CATEGORY: Recommended to aid quick change with environmental benefits.

NOTE: For further information regarding this Technical Bulletin please contact either of the contacts below quoting Technical Bulletin number **TB550-006** and your machine Serial Number. A complete library of technical bulletins is available on the company web site.

Chromed Steel Trimmer Starwheel

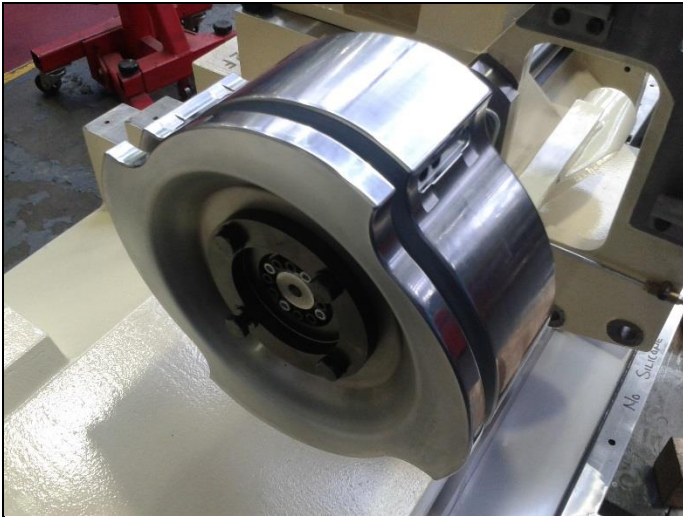
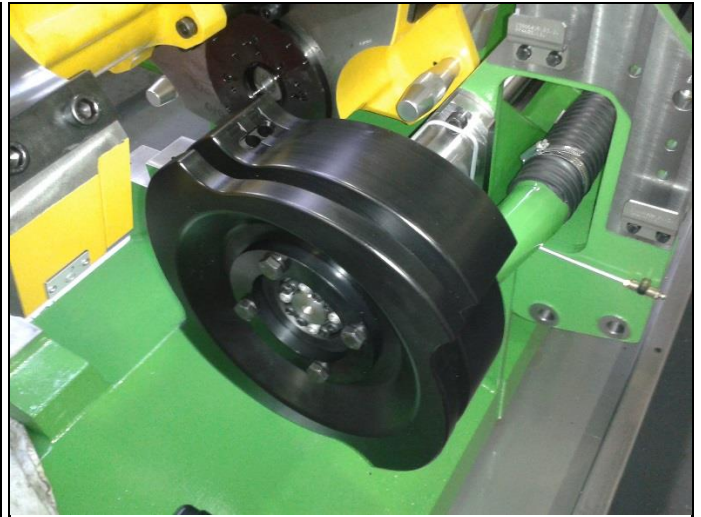
Summary: Where possible CMbE are reducing the amount of chrome plating on component parts due to the increasing difficulties of using this material because of its environmental impact. By changing the material to hard wearing plastic, this significantly reduces the weight without compromising performance. The plastic Trimmer Starwheel weighs approximately 80% less than the Chromed Steel Trimmer Starwheel making it ergonomically beneficial for manual handling during a change over.

Plastic Trimmer Starwheel
